ADMINISTRATIVE APPLICATION CHECKLIST

[D] Other: Specify: AMEND SWD-1420 BASED ON APPLICANT SUBMITTAL

OXY
API-30-025-26976
NBR Well #1
SWD-1420-A

From: Goetze, Phillip, EMNRD
Sent: Tuesday, July 23, 2013 2:56 PM
To: 'David_Stewart@oxy.com'
Cc: Joseph_Michael@oxy.com; Gonzales, Elidio L, EMNRD; Kautz, Paul, EMNRD; Ezeanyim, Richard, EMNRD
Subject: RE: OXY USA Inc. - NBR #1 SWD - 30-025-26976 - Recompletion to SWD

OXY USA Inc. - Current
NBR #1
API No. 30-025-26976

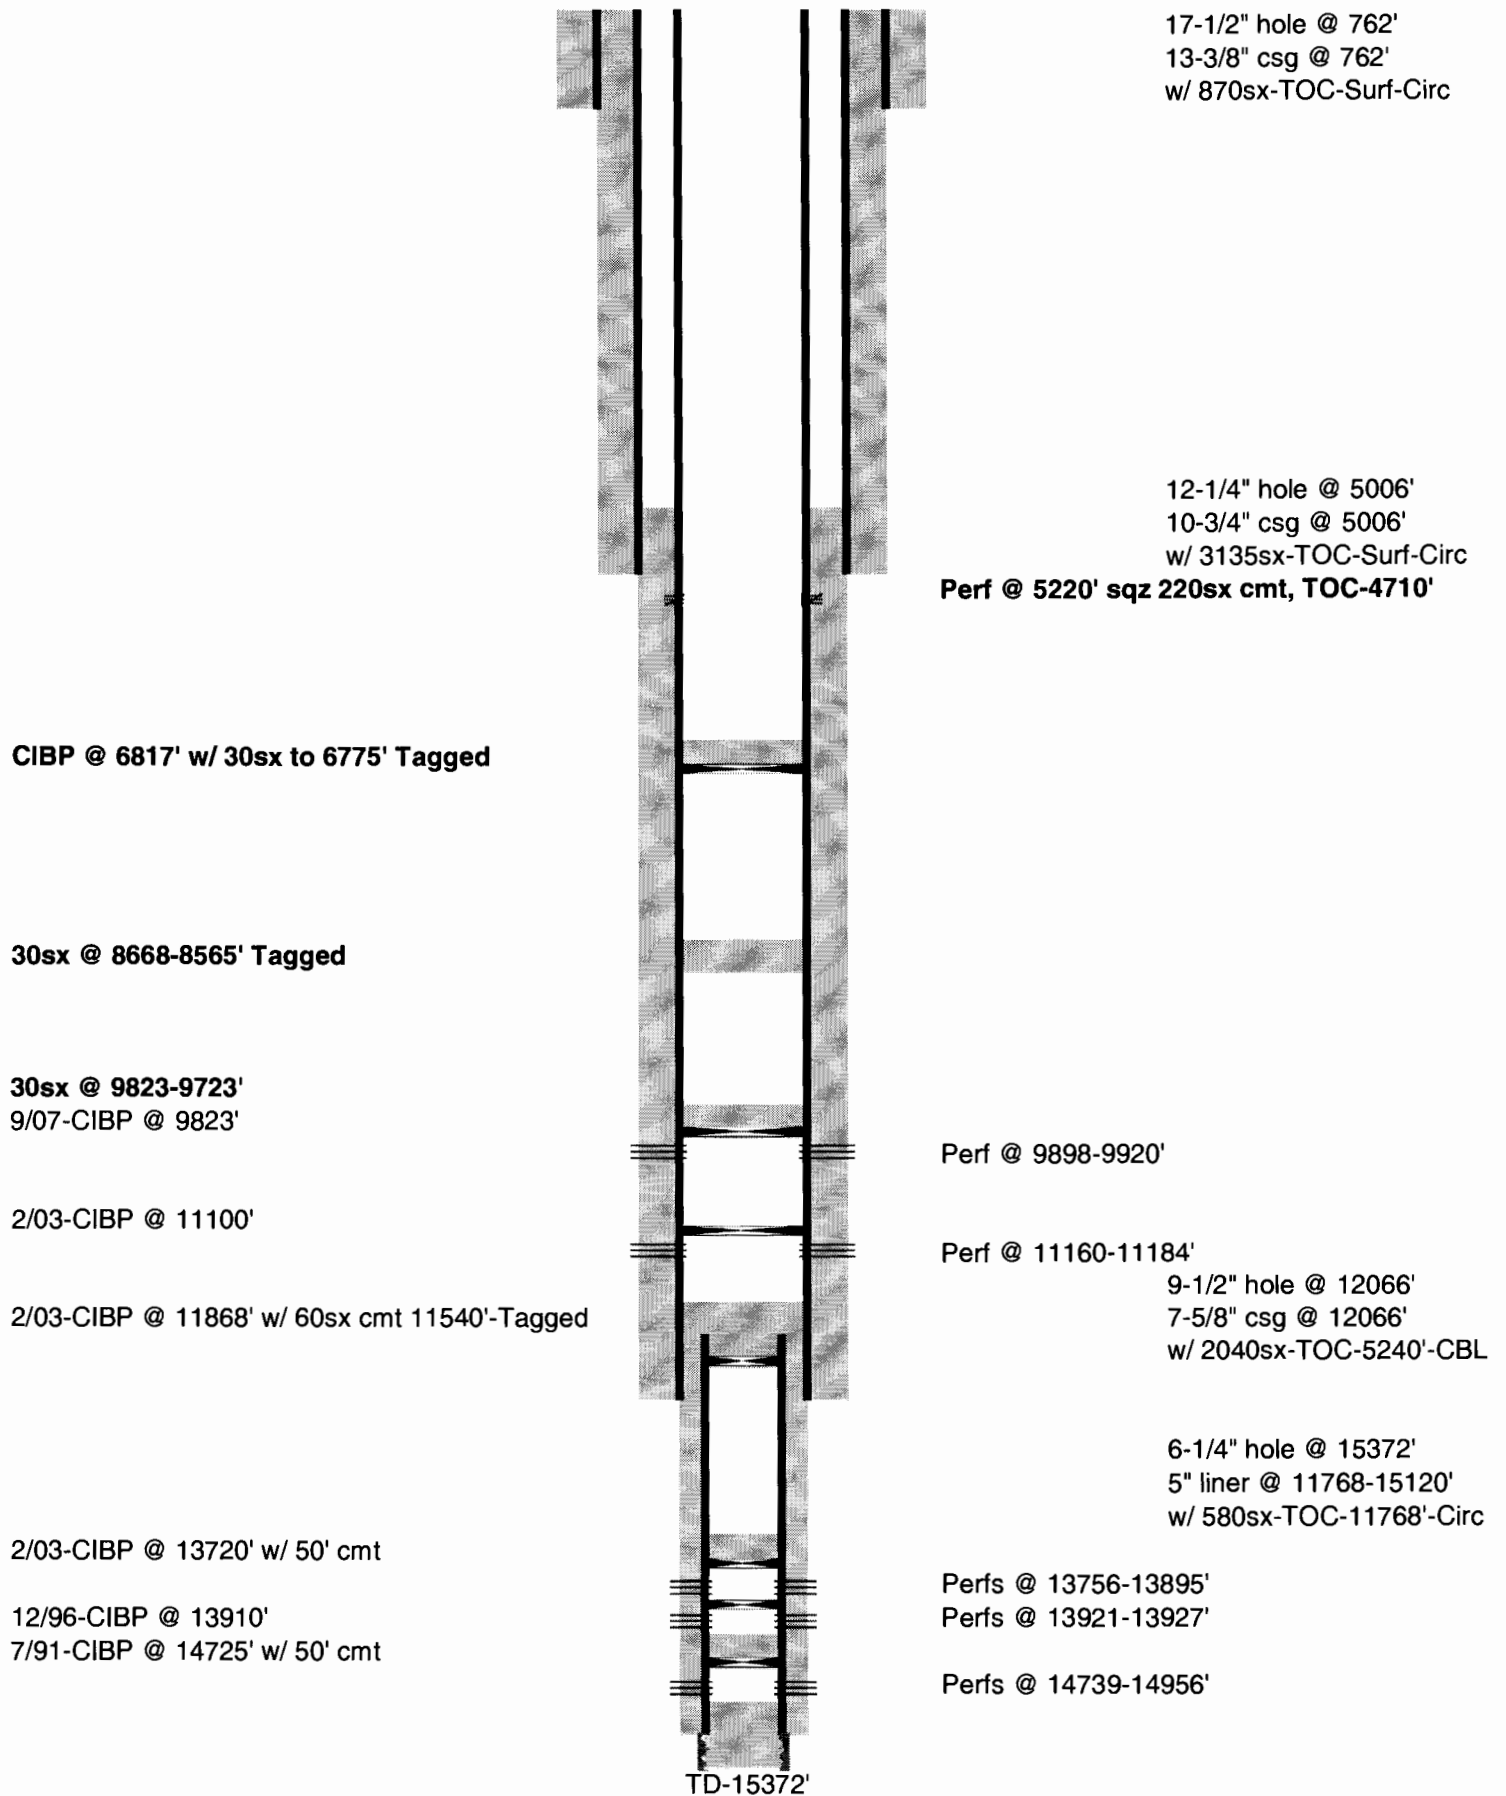
As mentioned on the phone, after reviewing the CBL, we TOC at 4,700'. For us to meet state regulation of 500' above top perf we would have to go back and do another cement squeeze. We want to perf between 5,018' – 5,280' as this is the best zone to inject into. The risk in doing that, is that we could potential perforate through 2 casing strings and if the cement squeeze isn't successful, we could create more damage by opening up a channel to contaminate fresh water.

The CBL shows that we have 300' of very good cement and should provide adequate isolation. Also above the Bell Canyon we have 100' of the Lamar which is a limestone and an Anhydrite zone, those 2 zones can also act as a barrier and will stop the frac from propagating upwards.

With that in mind, can we go back to the NMOCD and see if it would be ok go ahead and perf with only 300' of cement on top?

The package of information and the proposed changes in well construction have been reviewed with the Artesia District and with Richard Ezeanyim of the Engineering Bureau. It is OCD's opinion that the current TOC of 4710 ft for the 7 7/8-inch casing along with top perf being lowered to the proposed 5018 ft depth is sufficient to satisfy the requirements of the SWD permit. I will go and amend the existing permit to reflect the change in the top perf location and that the final TOC is acceptable.

You need to be aware: 1. that the packer will have to be located no shallower than 4918 ft based on the new shallow perf depth and 2. that the max surface inject pressure will increase to 1004 psi. Also, I need a clarification on the injection interval; you noted a lower perf of 5280 while the proposed C-108 completion showed 5998 ft for the lowest perf. Since I am amending the permit, what is going to be final interval, considering the planned life of the SWD well? Please provide some information regarding the last item. Thanks. PRG
